APPLICATION NO.	FILING DATE	FIRST NAMED INVENTOR	ATTORNEY DOCKET NO.	CONFIRMATION NO.
10/589,091	06/05/2007	Uwe Schierhorn	06-479	5492
34704 7590 12/29/2010 BACHMAN & LAPOINTE, P.C. 900 CHAPEL STREET SUITE 1201 NEW HAVEN, CT 06510				
EXAMINER				
KOAGEL, JONATHAN BRYAN				
ART UNIT		PAPER NUMBER		
3744				
MAIL DATE		DELIVERY MODE		
12/20/2010		PAPER

Office Action Summary

DETAILED ACTION

Fig. 1

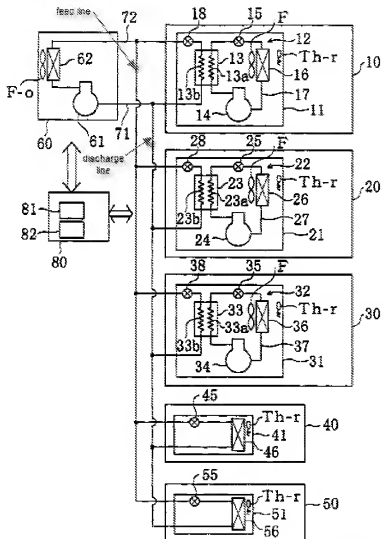
Regarding claim 1, Ueno teaches in fig. 1, a refrigeration installation having at least one refrigeration consumer 10, 20 which includes at least one evaporator 16, 26, having at least one feed line (See annotated figure below) and at least one discharge line (See annotated figure below), via which a refrigerant is fed to the at least one refrigeration consumer 10, 20 and discharged from the at least one refrigeration consumer 10, 20, the at least one refrigeration consumer 10, 20 having expansion members 15, 25 wherein, the expansion members 15, 25 comprise modified expansion valves, each said expansion member being connected upstream of the evaporator of each refrigeration consumer and each said refrigeration consumer 10, 20 being assigned a modified linear compressor 14, 24. Ueno fails to explicitly teach the

Regarding claim 15, Ueno as modified above teaches the invention as disclosed and Ueno further teaches in fig. 1, wherein the at least one refrigeration consumer 10, 20 has a dedicated closed refrigerant cycle 12, 22, the refrigerant cycle 12, 22 being operatively connected via at least one liquefier 13, 23 to the at least one feed line and the at least one discharge line, the refrigerant cycle 12, 22 in each case having modified expansion valves 15, 25 and modified linear compressors 14, 24, and the evaporator 16, 26 of said at least one refrigeration consumer 10, 20 in each case being arranged higher than the liquefier 13, 23 of the said at least one refrigeration consumer 10, 20 (column 4 lines 1-11, column 5 line 13-column 6 line 57). From a horizontal reference

point of view in fig. 1 where a left direction is defined as a lower point and a right direction is defined as a higher point, the evaporator is arranged higher than the liquefier.
